Access Compliance Report

Public Rights-of-Way

(Curb Ramps)

Intersection ID: 53775	Main Street: STRAWBERRY_FIELDS_LN	Cross Street: CHAPECLANE_RD	Location: NE
ADA ID: 67FBD5E0854A	Ramp Type: BlendTrans1	Initial Pass/Fail: Fail	Overall Compliance: No
			Severity Score: 21.25

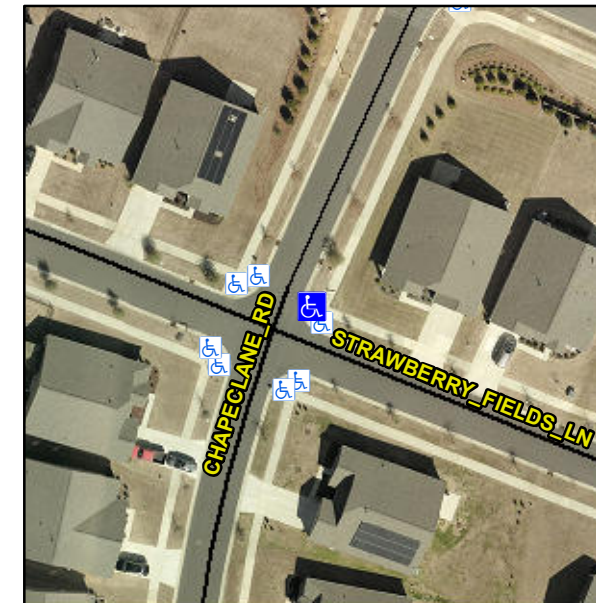
R304.5.1, R304.5.3

Compliance	Description	Data	Compliance	Description	Data
N/A	Ramp Length (in)	94.0	Yes	BlendTrans Slope (%)	0.3
No	Ramp Width (in)	46.5	No	BlendTrans XSlope (%)	6.1
N/A	Flare Type LT	N/A	N/A	Flare Type RT	N/A
N/A	Flare Slope LT (%)	N/A	N/A	Flare Slope RT (%)	N/A
N/A	Flare Traversable LT?	N/A	N/A	Flare Traversable RT?	N/A
N/A	Landing Length (in)	N/A	N/A	DWS Provided?	N/A
N/A	Landing Width (in)	N/A	N/A	DWS Contrast?	N/A
N/A	Landing Slope (%)	N/A	N/A	DWS Length (in)	N/A
N/A	Landing X Slope (%)	N/A	N/A	DWS Full Width?	N/A
N/A	Landing Curb? (Y/N)	N/A	N/A	DWS Offset (in)	N/A
N/A	Shared Landing?	N/A			
N/A	Gutter Ponding?	N/A	N/A	Gutter Slope (%)	N/A
N/A	Gutter Lip Ht (in)	N/A	N/A	Gutter X Slope (%)	N/A
N/A	Painted X Walk1?	No	N/A	Painted X Walk2?	N/A
	X Walk 1 Direction	To NW		X Walk 2 Direction	N/A
	X Walk 1 Width (in)	N/A		X Walk 2 Width (in)	N/A
	X Walk 1 Slope (%)	3.2		X Walk 2 Slope (%)	N/A
	X Walk 1 X Slope (%)	4.4		X Walk 2 X Slope (%)	N/A

Remove & Replace Curb Ramp With Two New Directional Ramps or Equivalent.
